**City of Urbandale  
Supplemental Specifications  
To Iowa Statewide Urban Design and Specifications  
Standard Specifications for Public Improvements – 2022 Edition  
February 2022**

FIGURE 7030.101 SHEET 1 OF 1

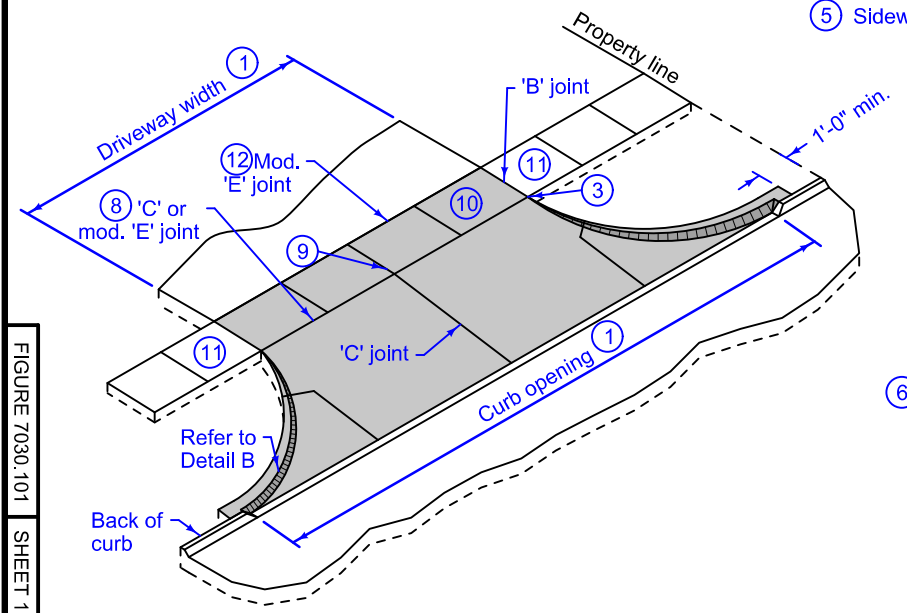
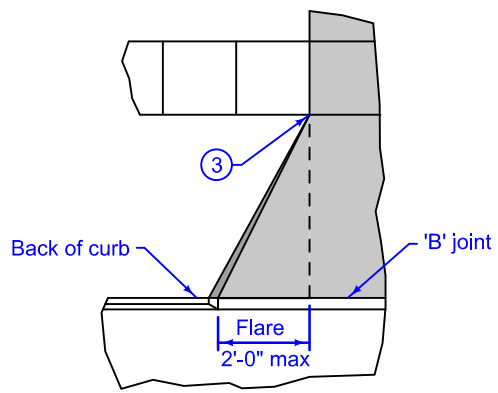
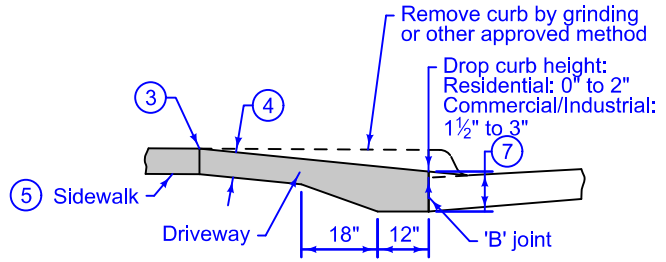
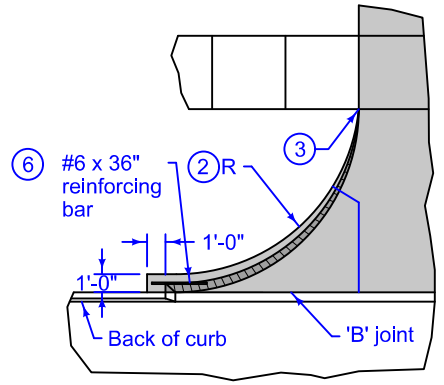
- ① Driveway width (W).  
Residential: 8 foot minimum, 24 foot maximum at sidewalk and at property line, 28 foot maximum at street.  
Commercial and industrial: As specified in the contract documents.

- ② Driveway radius (R).  
Residential: 10 foot minimum, 15 foot maximum.  
Commercial and industrial: As specified in the contract documents.
- ③ Transition the curb height to 0 inches at end of taper/radius or at the front edge of sidewalk. Do not extend raised curb across sidewalk.

- ④ Pavement thickness.  
Residential: 6 inches minimum.  
Commercial and industrial: 7 inches minimum.
- ⑤ Sidewalk thickness through driveway to match thickness of driveway.

- ⑥ Center reinforcing bar vertically in the pavement.
- ⑦ Match thickness of adjacent roadway, 8 inches minimum.
- ⑧ Provide 'C' joint when sidewalk and drive approach are both being built.  
Provide 1/2" 'E' joint when sidewalk is existing.

- ⑨ For alleys, invert the pavement crown 2% toward center of alley.
- ⑩ Target cross slope of 1.5% with a maximum cross slope of 2.0%. If specified in the contract documents, construct the sidewalk through the driveway 6 feet wide to serve as a passing space.

- ⑪ If cross slope of adjacent sidewalk panel exceeds 2.0%, remove and replace to transition from existing sidewalk to sidewalk through driveway. If elevation change requires a curb ramp, comply with SUDAS Figure 7030.206; verify need for detectable warning panel with Engineer.

- ⑫ Use 1/2" expansion joint material.

**CONCRETE DRIVEWAY, TYPE A  
EXISTING PAVING, CURB GRINDING**

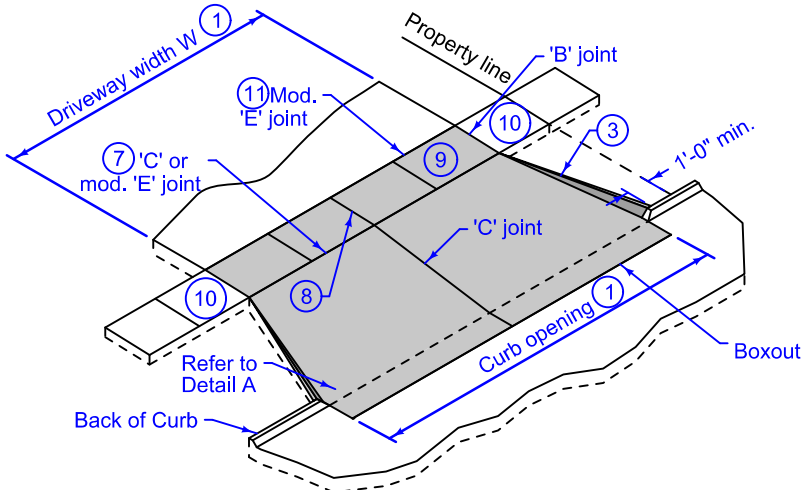
THIS DETAIL ONLY TO BE USED WITH PRIOR APPROVAL FROM CITY OF URBANDALE ENGINEERING DEPARTMENT.

URBANDALE STANDARD SPECIFICATIONS	REVISION 04-29-16 <b>7030.204</b>
	SHEET 1 of 1	
GENERAL FEATURES OF AN ACCESSIBLE SIDEWALK

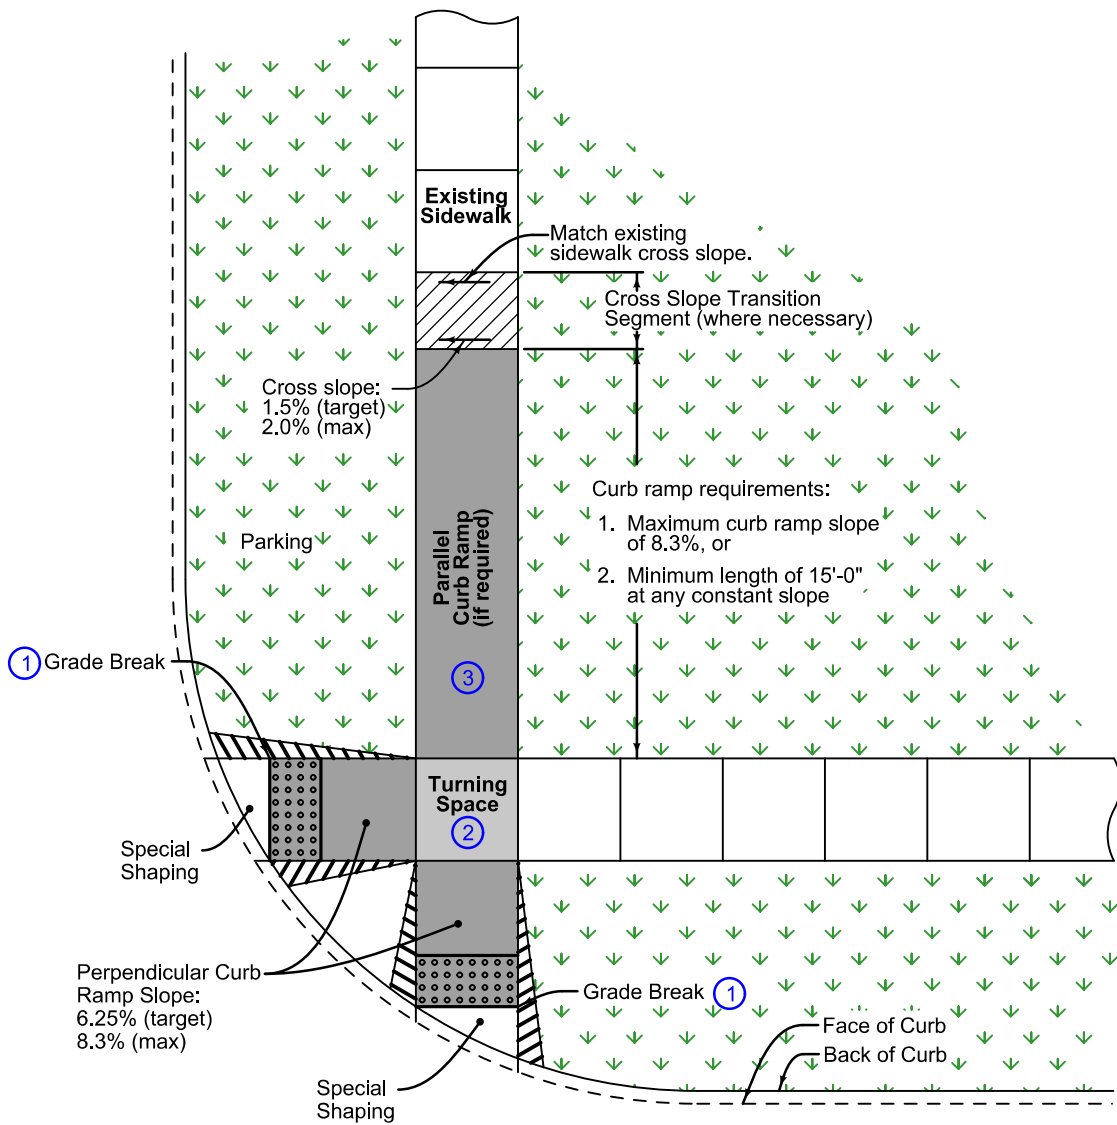
- ① Match pedestrian street crossing slope, or flatter.
- ② Minimum 5 feet by 5 feet, unless approved by Engineer. Target slope = 1.5%; maximum slope = 2.0% perpendicular to adjoining sidewalks and curb ramps.
- ③ All Urbandale Sidewalks to be 5 feet wide, unless approved by Engineer.
- ④ Detectable warning panels to be Armor Tile, ADA Solutions, or approved equal, brick red in color. Brick pavers will not be allowed.
